**DRAINAGE REPORT  
FOR  
FLEXJET  
15115 N. AIRPORT DRIVE  
SCOTTSDALE, ARIZONA 85260**

Job Number 21-028  
April 23, 2024  
Rev: March 12, 2025

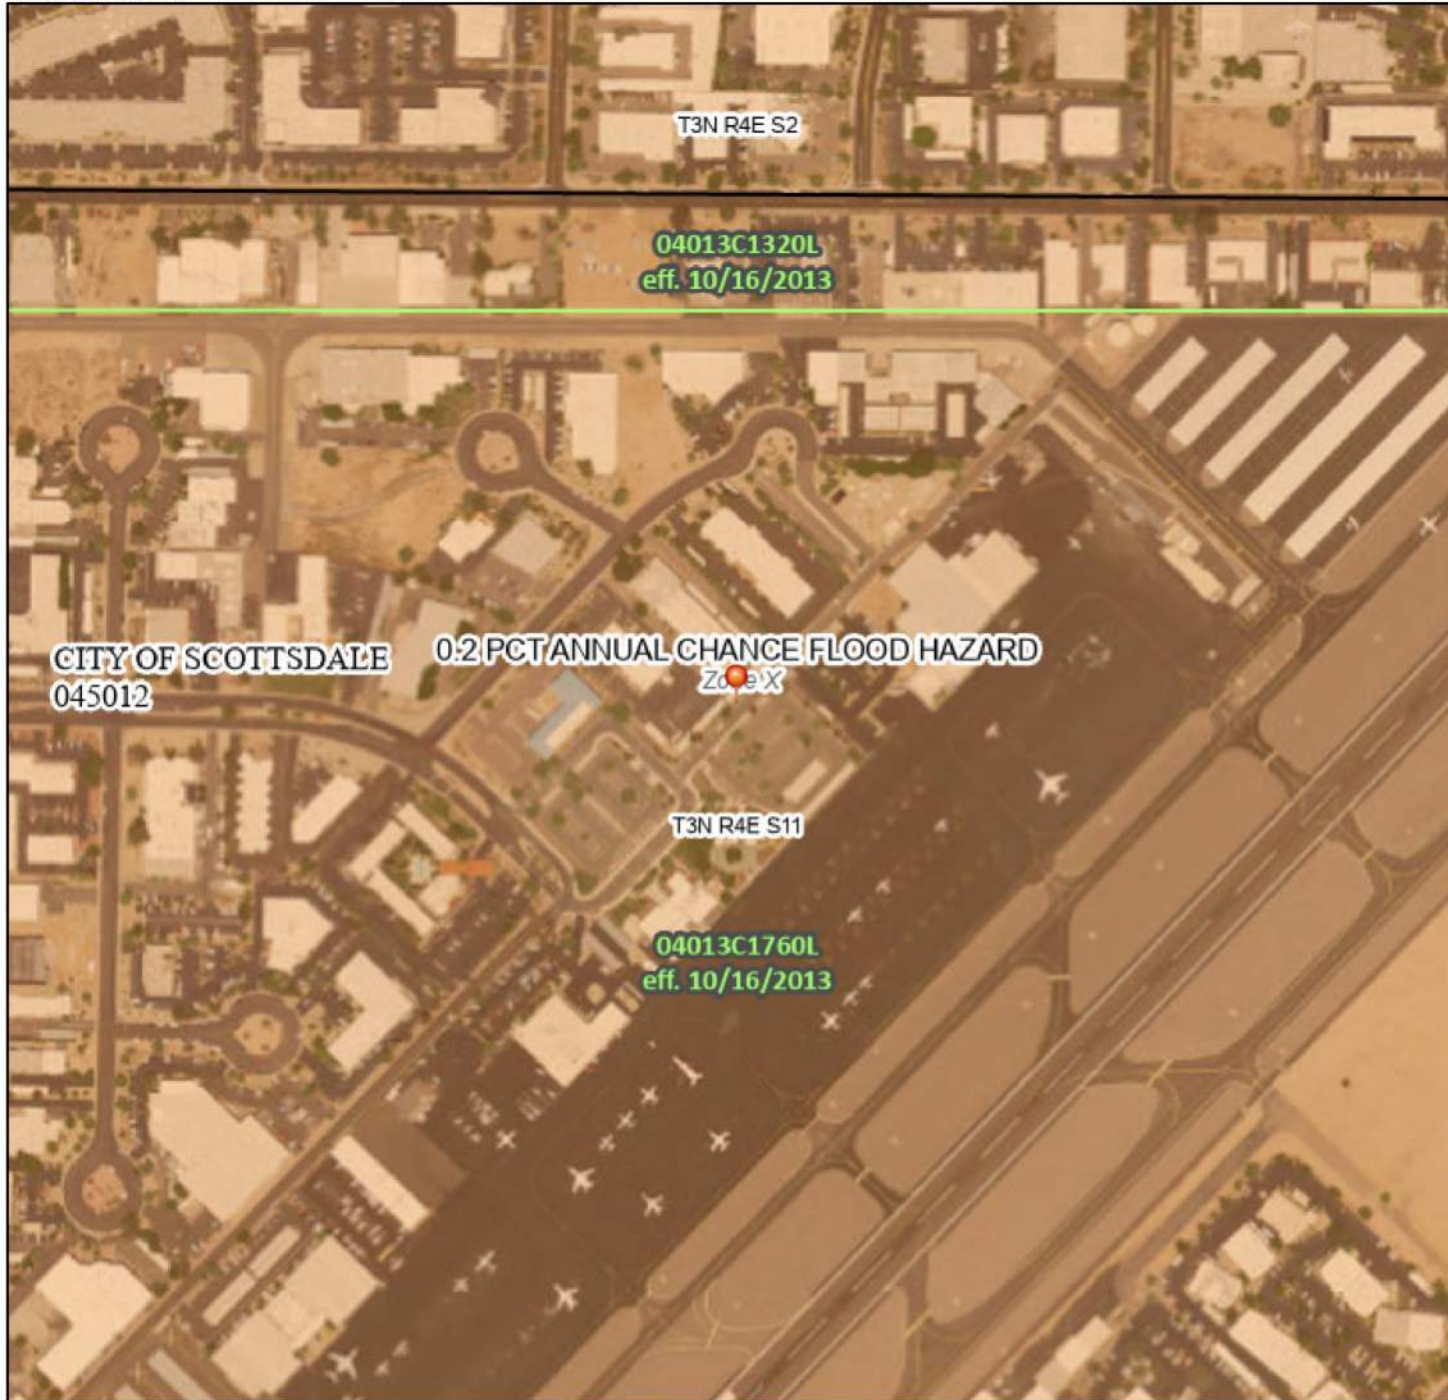
On site drainage is handle by airport storm drain, then collect by a basin, not city sewer

Use tc =5min for Q100 calculation.

from previous plan
